## B. Zoning for Regulatory Guide

**Table 3-1: Zoning Summary for Initial Planning Area**

**Figure 3-9: Conceptual Design for Neighborhood 3**

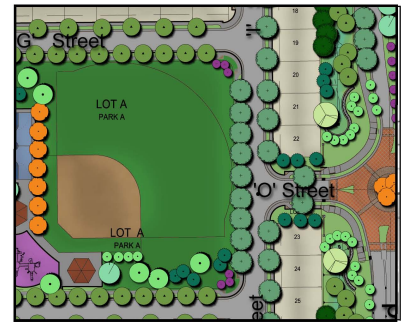
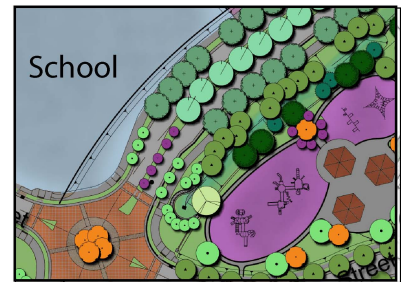
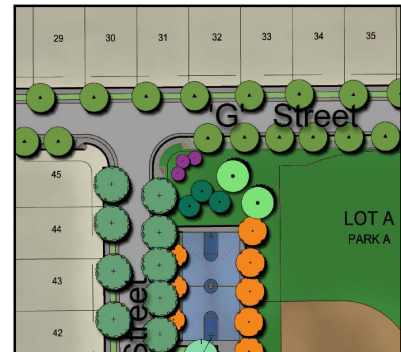
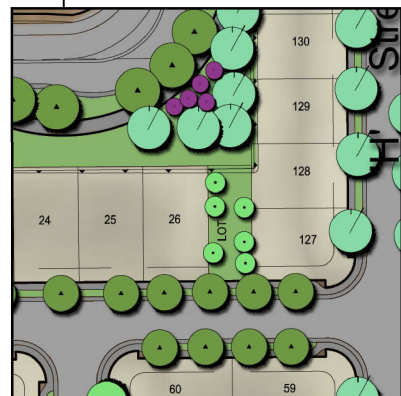
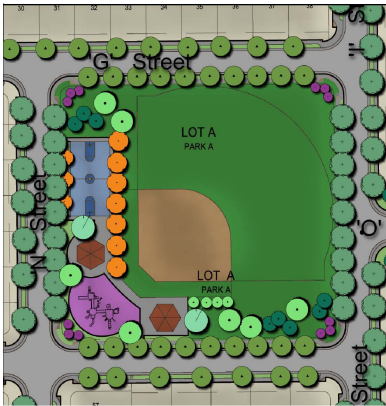
- ❑ A central east/west automobile corridor should be provided through the neighborhood and terminate at the Community Park. ~~This street should incorporate traffic calming measures such as roundabouts, corner bulb-out's, or other features to slow traffic speeds.~~

- ❑ In order to create view corridors through the neighborhood and out to its edges, ~~major paseos and live-end cul-de-sacs~~ should be sited strategically through the neighborhood and respond to the street layout and enhance view sheds into adjacent open space preserves and linear parkways~~the gridded development pattern. Where paseos are used to create a view/access corridor from the neighborhood's edge to its interior, the paseo should be aligned with a street to create a linear, unobstructed passageway.~~

- ❑ To enhance permeability in and out of the neighborhood, automobile access points and paseos should be enhanced with landscape corridors and pedestrian lotting patterns ~~and corresponding home siting should utilize minor paseos and garage lanes to create additional view corridors and~~ passageways from the neighborhood's interior to edge roadways and open space areas.

- ❑ A north/south linear paseo linkage should be provided ~~through the residential blocks, which provides a view corridor and to create~~ pedestrian connection between the neighborhood's northern and central park spaces. Residential units should be oriented to this linkage, with front doors, porches, and fenestration that visually activate the corridor.

- ❑ ~~Attached or e~~Compact, small lot housing types should flank, or be sited in proximity to, the northern park near the school site. The

- ☐ ~~Where HDR units have a direct interface with a park site, they should be oriented to the park space, using features such as front doors, porches, stoops, balconies, and/or fenestration that look onto the park and visually define the edge.~~

- ☐ ~~Homes should be oriented to the linear parkways along the Central Boulevard and the western edge of the neighborhood, as well as the community park, such that front doors, porches, fenestration, and other features activate these streetscapes and visually integrate them with the entire neighborhood.~~

- ☐ At least ~~four~~three different housing types should be provided throughout the neighborhood, including both single-family detached, single-family attached, and multi-family attached, as provided for in Section 4.2 of this GDP. This could include a mixture of compact housing types~~conventional front-loaded homes, cluster homes, paired homes, and attached townhomes or stacked flats.~~

Figure 3-10: Conceptual Design for Neighborhood 4

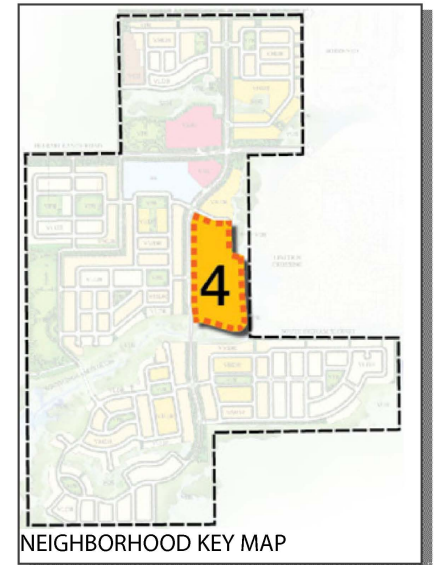
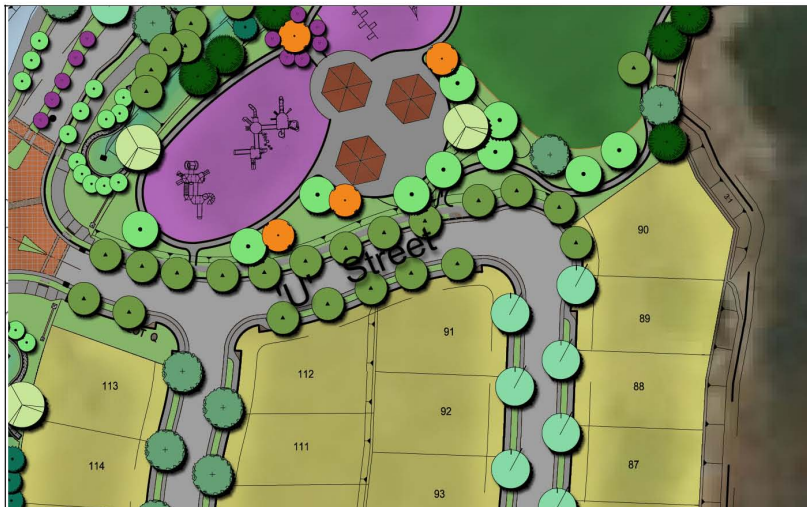
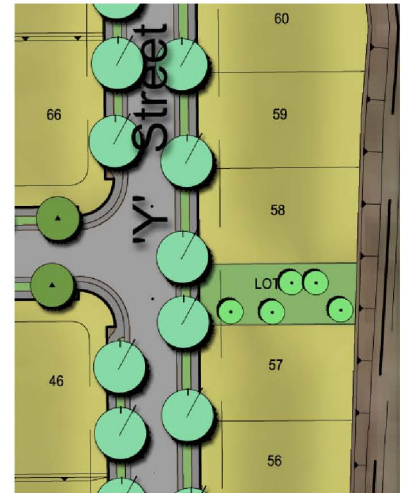
- ☐ ~~In order~~ Paseos should be incorporated at select locations to create view corridors ~~throughout the neighborhood as shown on Figure 3-10, paseos should be sited strategically to respond to the street layout and development pattern. Where paseos are used to create a view/access corridor from the neighborhood's edge to its interior to adjacent open space, and where feasible, the paseos~~ should be aligned with ~~a streets~~ to create a linear, unobstructed passageway.

- ☐ ~~Homes should be oriented to the linear parkways along the Central Boulevard, as well as to the open space areas along Ingram Slough, such that front doors, porches, or other features activate these edges and visually integrate them with the entire neighborhood.~~

- ❑ ~~At least three different housing types should be provided throughout the neighborhood, including either single family detached, single family attached, or multi family attached, as provided for in Section 4.2 of this GDP. This could include a mixture of lane loaded homes, paired homes, cluster homes, and attached townhomes or stacked flats.~~

- ❑ Fencing along the Central Boulevard should be ~~limited,~~ provided where needed to provide privacy for individual yards, but designed in a manner that ~~does not create~~ a hard-visually attractive edge. Fencing along open space areas should provide privacy for individual yards, but should be designed in a manner that does not create a hard edge along this feature. (See Section 7.3 for fence requirements.)

Location and design of street networks ~~and~~ paseos, ~~and garage lanes~~ create view corridors through neighborhood ~~from Central Boulevard to open space areas~~

~~Village Center's multi-family homes integrated with single family neighborhood with all units fronting on to a common street~~
